UNITED STATES PATENT AND TRADEMARK OFFICE

Office Action Summary

10/690,933

ELLIS, FRAMPTON E.

FIG. 27

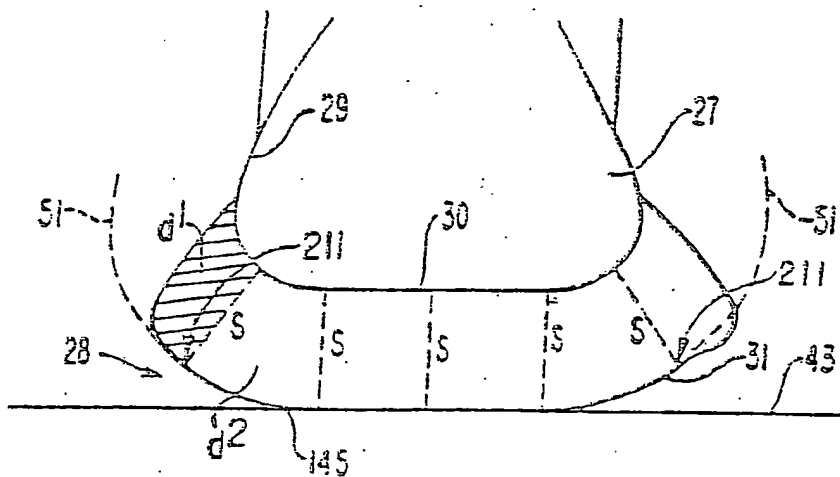
1. The drawings are objected to under 37 CFR 1.83(a). The drawings must show every feature of the invention specified in the claims. Therefore, the shoe sole with both thickness and density variations must be shown or the feature(s) canceled from the claim(s). No new matter should be entered.

Corrected drawing sheets in compliance with 37 CFR 1.121(d) are required in reply to the Office action to avoid abandonment of the application. Any amended replacement drawing sheet should include all of the figures appearing on the immediate prior version of the sheet, even if only one figure is being amended. The figure or figure number of an amended drawing should not be labeled as "amended." If a drawing figure is to be canceled, the appropriate figure must be removed from the replacement sheet, and where necessary, the remaining figures must be renumbered and appropriate changes made to the brief description of the several views of the drawings for consistency. Additional replacement sheets may be necessary to show the renumbering of the remaining figures. Each drawing sheet submitted after the filing date of an application must be labeled in the top margin as either "Replacement Sheet" or "New Sheet" pursuant to 37 CFR 1.121(d). If the changes are not accepted by the examiner, the applicant will be notified and informed of any required corrective action in the next Office action. The objection to the drawings will not be held in abeyance.
